# UNITED STATES PATENT AND TRADEMARK OFFICE

APPLICATION NO.	FILING DATE	FIRST NAMED INVENTOR	ATTORNEY DOCKET NO.	CONFIRMATION NO.
10/527,967	09/26/2005	Johann Ambrosi	740612-193	7462

<b>Office Action Summary</b>	Application No. 10/527,967	Applicant(s) AMBROSI, JOHANN	
	Examiner JAY R. RIPLEY	Art Unit 3679

### **DETAILED ACTION**

FIG. 10

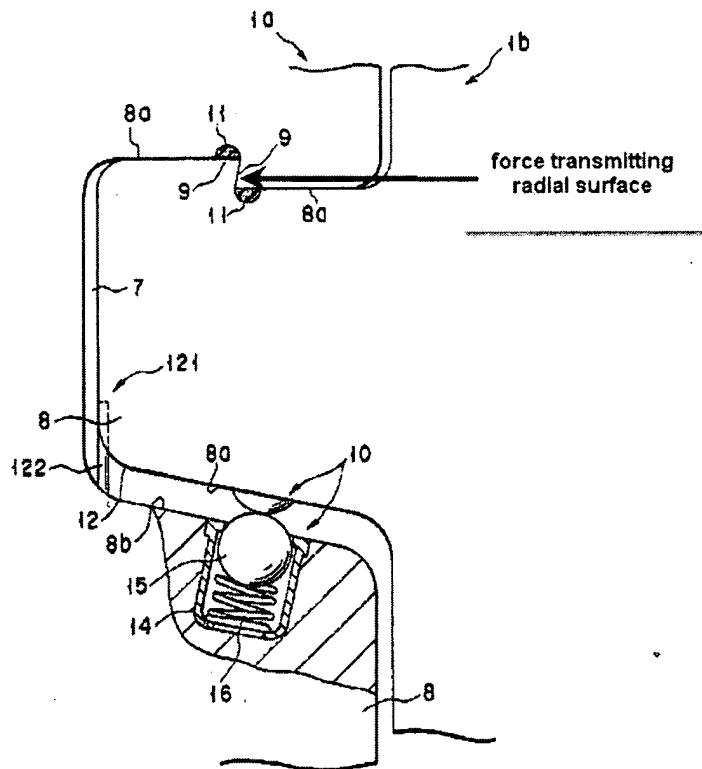
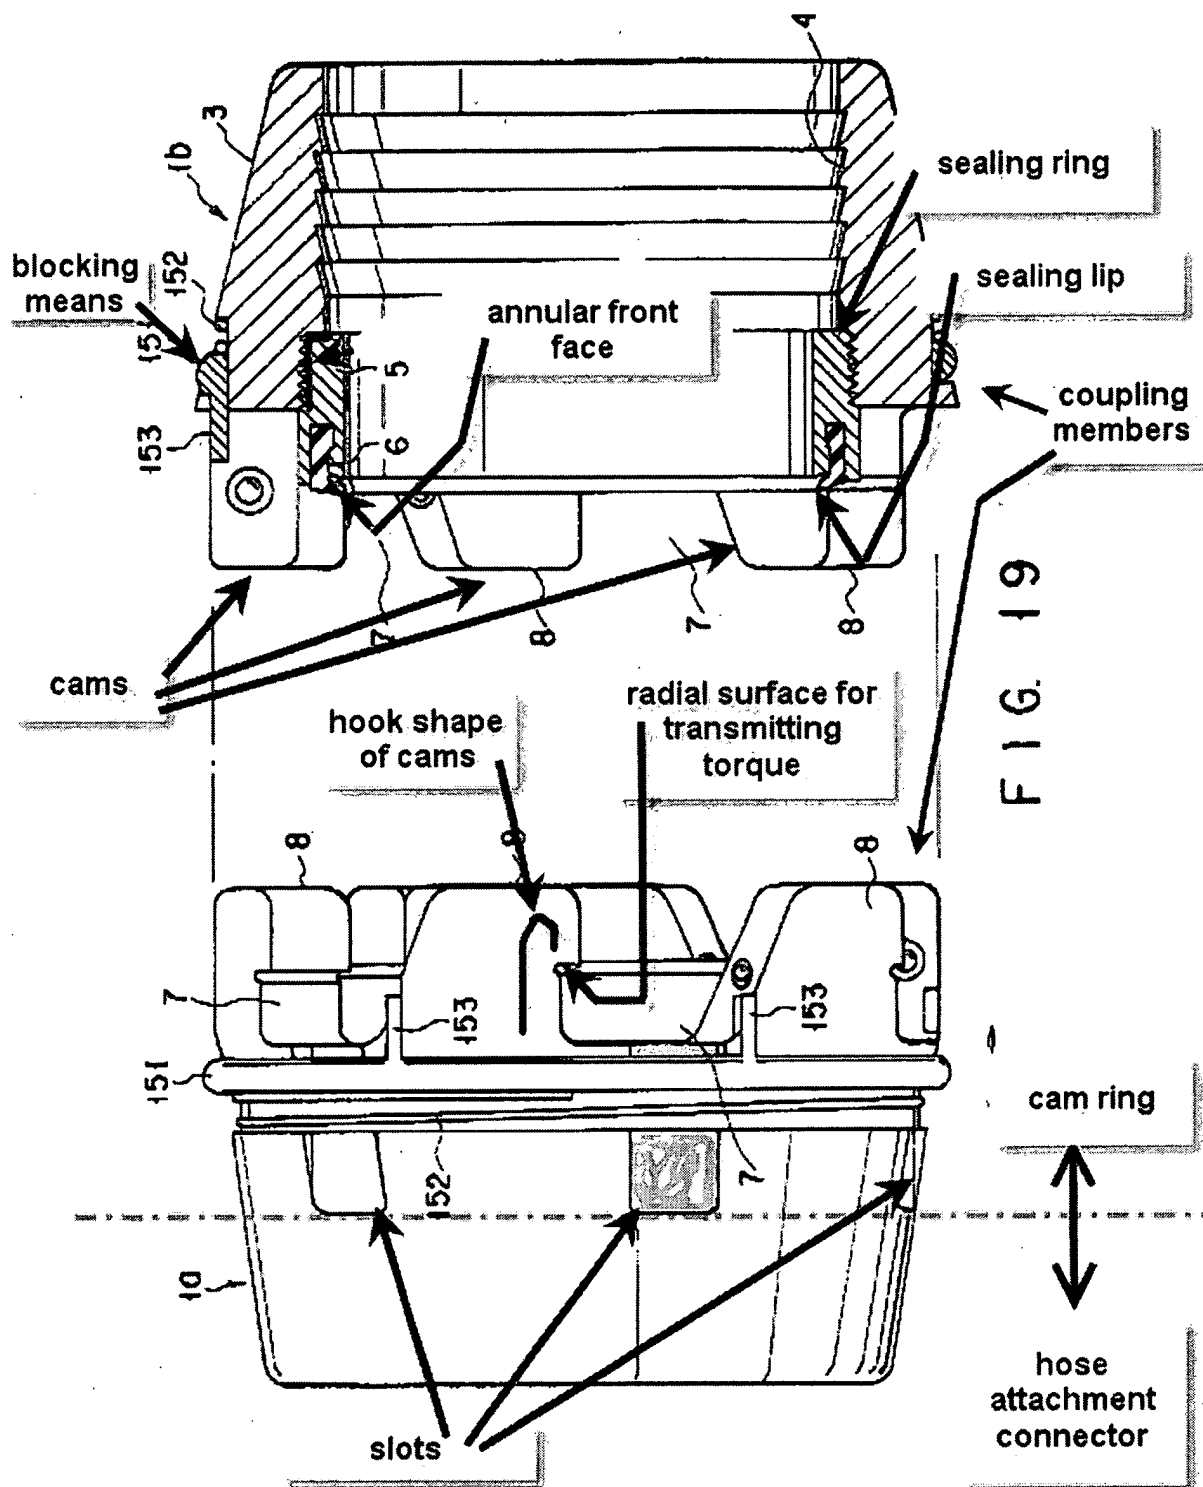
In regard to claim 1, Horimoto discloses in Figure 10 and Figure 19, the figures shown below, a symmetrical hose coupling comprising

the cam ring having a plurality of integral cams (8) arranged on the periphery of the cam ring and projecting from the cam ring (the slots noted in Figure 19, below and in Attachment A, result in the cams projecting radially from the cam ring - the blocking means appears to be positioned by the slots - note that the slots "bottom", radially inner surface, is the outer radial surface of the cam ring), the cams being hook-shaped in a tangential direction of the cam ring and each having a radial surface area (9 in Figure 10) for transmitting an axial force, and the

In regard to claim 7, Horimoto further discloses that the radial surface areas of the cams are inclined in relation to the tangential direction (column 8, lines 26-30, and observed in Figure 10, above).

(Horimoto Figure 19)

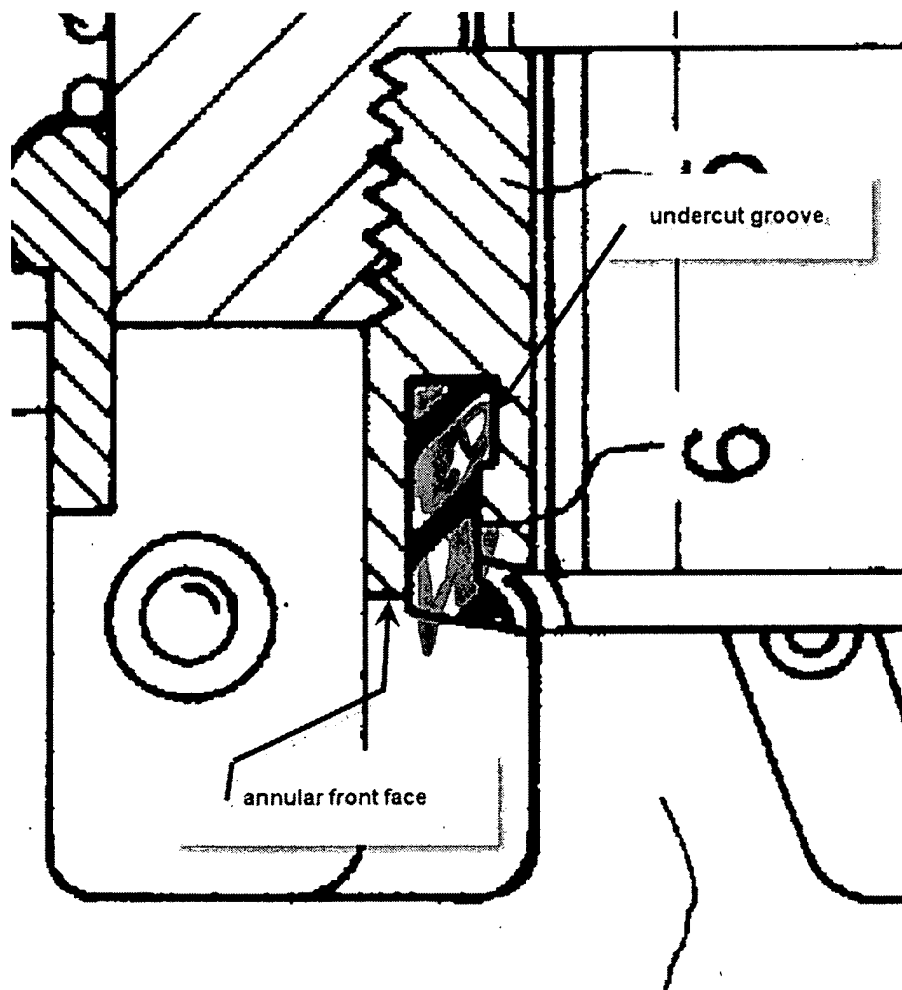
a pair of like coupling members (1a and 1b, as observed in Figure 19, below),

each of the coupling members having a cylindrical hose attachment connector (4) and a cam ring integrally formed with the cylindrical hose attachment connector (as observed in Figure 19, below),

In regard to claim 8, Horimoto further discloses, in Figure 19, above, and close-up of Figure 19, below, that the cam ring has an annular front face radially inwardly of the cams and an annular undercut groove is recessed in the annular front face for receiving a shaped sealing ring having a sealing lip which protrudes axially beyond the front face of the cam ring.

In regard to claim 10, Horimoto further discloses that a blocking means (lock claws 153 as observed in Figure 19, above, and as disclosed in column 13, lines 19-34) are provided for locking the pair of coupling members with each other in a coupled condition.

FIG. 19

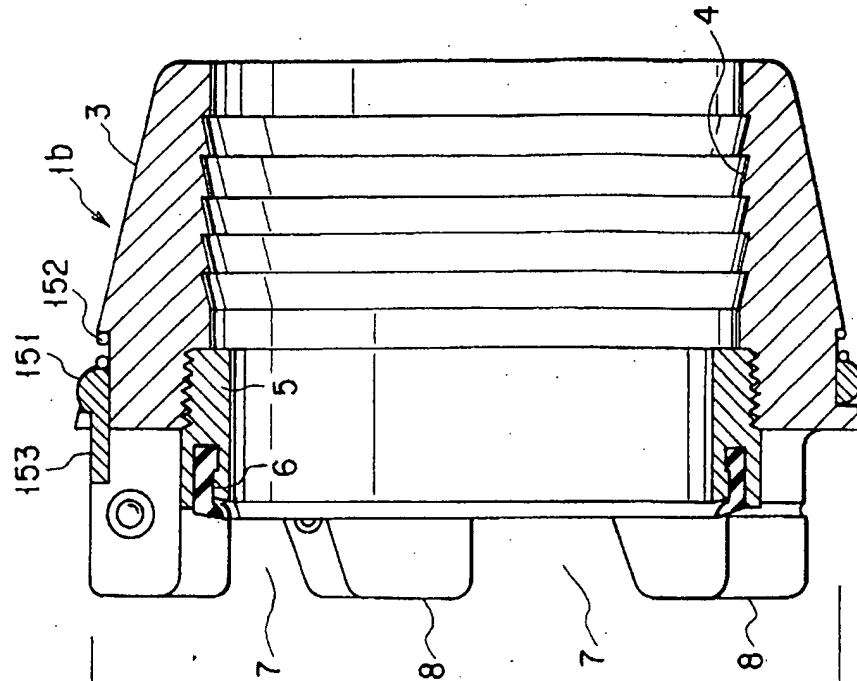
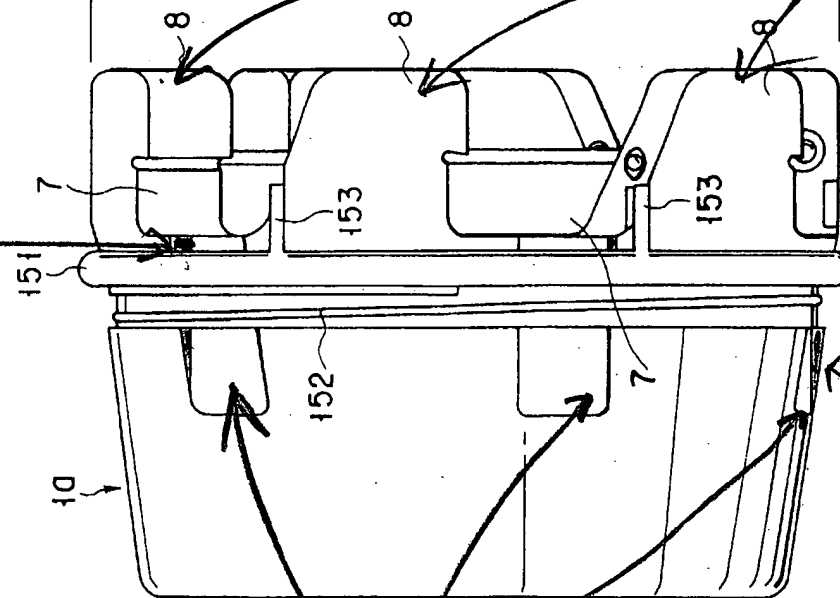
Concerning the Applicant's assertion starting in page 6, line 9, of the reply filed 17 December 2007, that the prior art of Horimoto (U.S. 5,857,713) does not teach or suggest cams that project radially from a cam ring, the argument is not persuasive. As can be observed in Horimoto Figure 19, see Attachment A, the slots as first noted in page 7 of the Office action mailed 06/19/2007 result in the cams of Horimoto projecting radially from the noted cam ring. As specifically noted in Attachment A, Figure 19 shows "side" surfaces (shaded in

Attachment A) of the noted slots, thereby further buttressing the interpretation that the cams of Horimoto project radially from the cam ring. The Examiner notes that the cam ring outer circumference is the "bottom" radial surface of the noted "slots".

CAMS

NOTE  
"SIDE"  
SURFACE  
(SHADED)

SLOTS RESULTS IN CAMS  
PROJECTING RADIALLY FROM  
CAM RING.
